SERVICE BULLETIN

APPLICABILITY: 2019MY Ascent **NUMBER:** 12-265-19
SUBJECT: EyeSight Camera Cover (Sunglasses Holder Portion)- Design Change **DATE:** 06/11/19

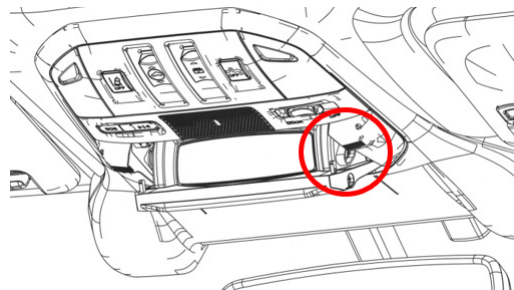
This bulletin announces a design change made to the sunglasses holder portion of the EyeSight camera cover. In rare cases, the sunglasses holder may bind or otherwise not operate smoothly when trying to open and / or close it. The mechanism has been changed in the area circled in the illustration below to eliminate binding and provide smooth operation during opening and closing.
